Change Order Estimate

JEO Project Name: 100380		JEO Project Number: 100380			
Owner: City of Lexington, NE		Change Order Number: 1			
Contractor: Road Builders Inc.		Effective Date: September 8, 2015

Change Order No. 1, Attachment No. 1

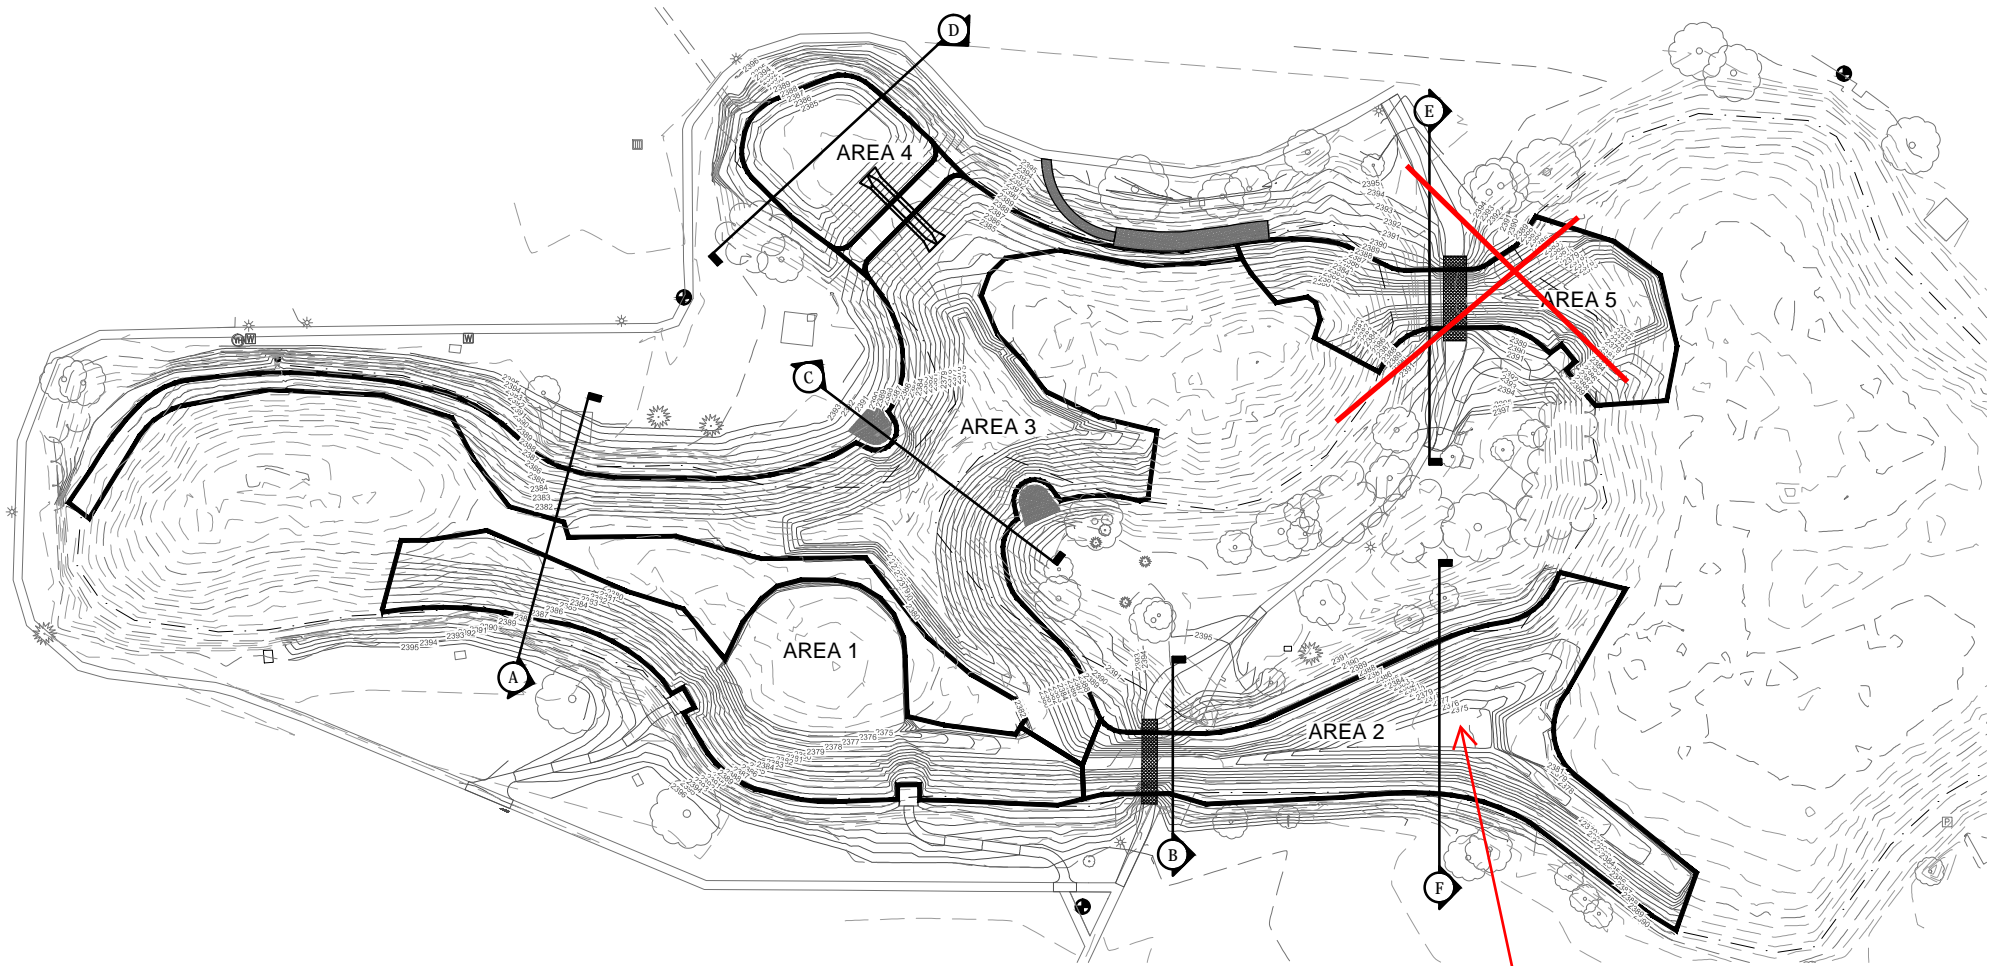
this area can be reduce to hit the total quantity of 9000 CY

- The bid item, Clearing and Grubbing (Bid Item No. 2) has been reduce from \$60,000 to \$50,000.
- The quantity of proposed Lake Dredging (Bid Item No. 3) has been reduced from 12,105 CY to 9,000 CY primarily through the reduction of excavation in dredging Area 5 and through as needed additional reduction of excavation in dredging Area 2.
